South Texas Project
Units 1 & 2
Docket Nos. STN 50-498, STN 50-499
Responses to NRC Questions Regarding
Bottom Mounted Instrumentation Penetration Indications

Responses to NRC Questions

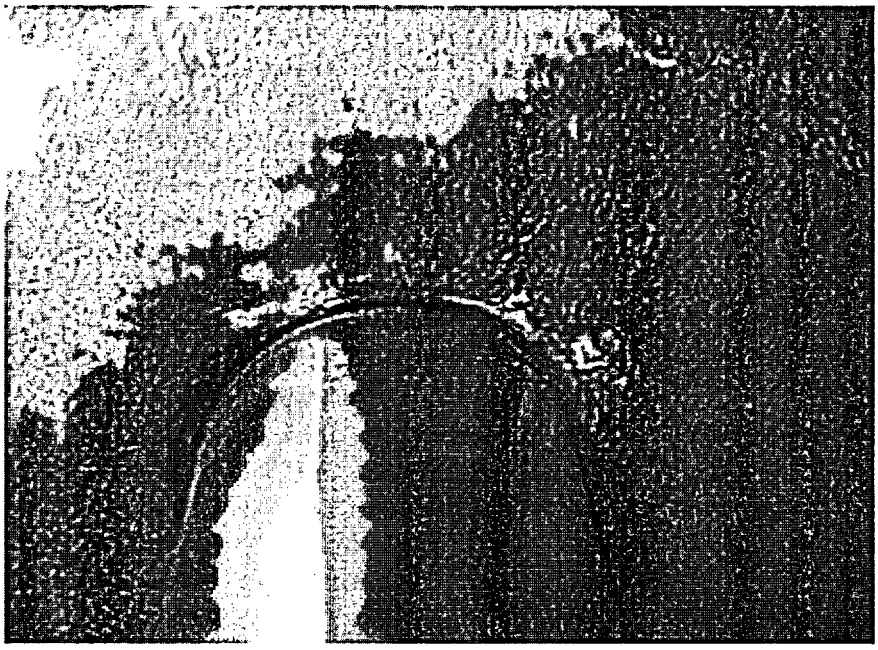
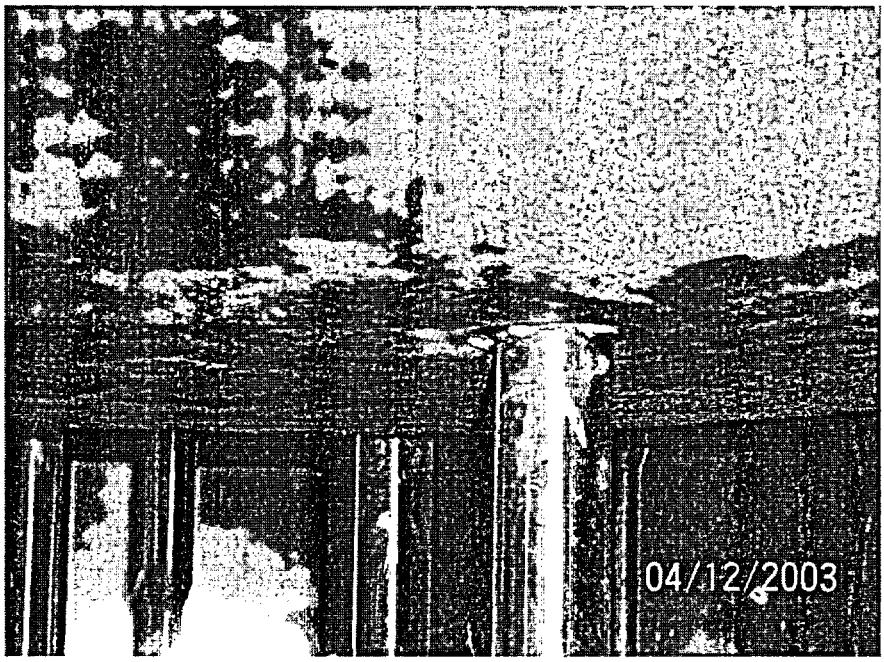
9. Please explain the apparent groove or gap in the photograph of Penetration 1.

There is no groove or gap. A closeup photo from a video taken after the residue was removed shows a better view of Penetration 1. The penetration openings are chamfered. This photograph shows that the chamfer is still clearly defined. A photograph of Penetration 1 prior to cleaning is provided for comparison.

STP BMI Generic J-Groove Configuration

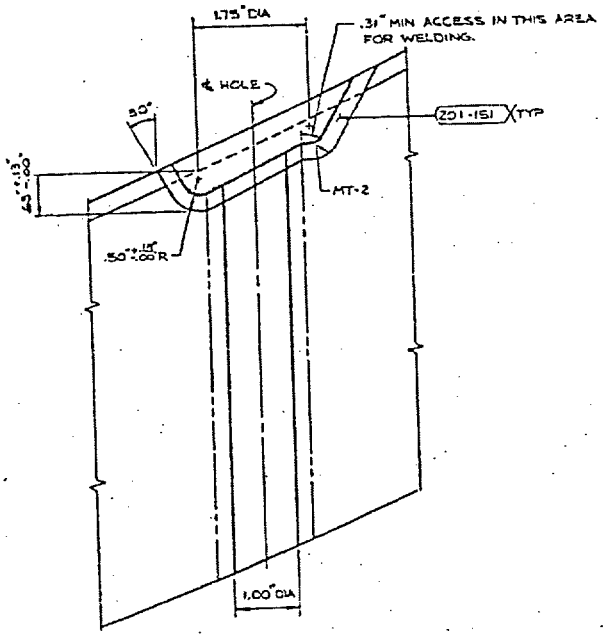
11. Provide J-groove weld dimensions

See attached diagrams.

STP BMI J-groove weld dimensions from Question 11.
